## RENESAS TECHNICAL UPDATE

Product Category	MPU/MCU		Document No.	TN-SH7-A817A/E	Rev.	1.00
Title	The error correction and addition about LCD controller (LCDC)		Information Category	Technical Notification		
Applicable Product	SH7763 Group	Lot No.	Reference Document	SH7763 Hardware Manual (REJ09B0256-0200)

Figure 37.4 Flowchart for Power-Supply Control Sequences

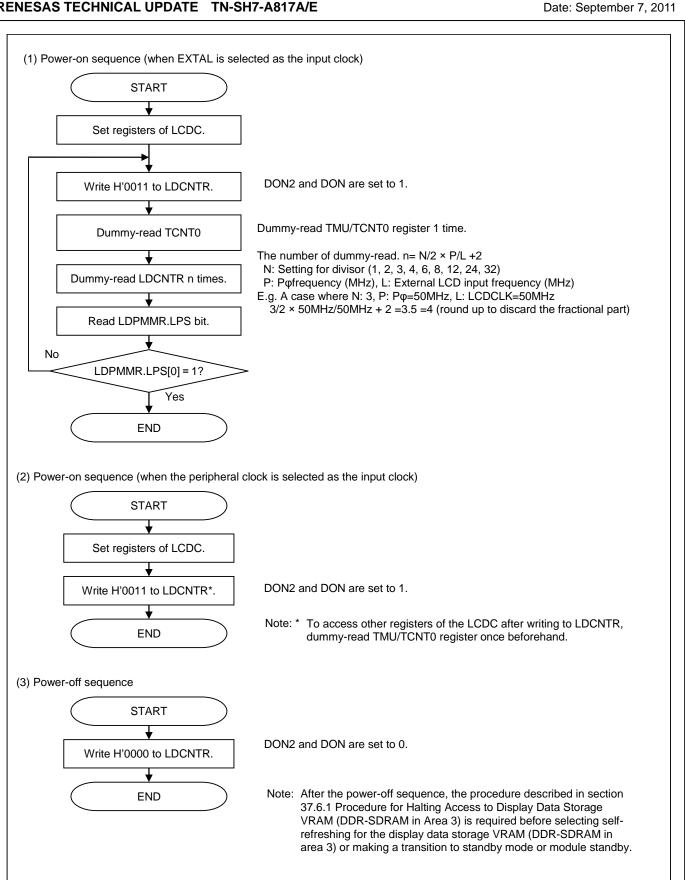
## 2. Added Figure 37.4

Figure 37.4 to 37.23 are re-numbered to Figure 37.5 to 37.24 respectively, then add new Figure 37.4.
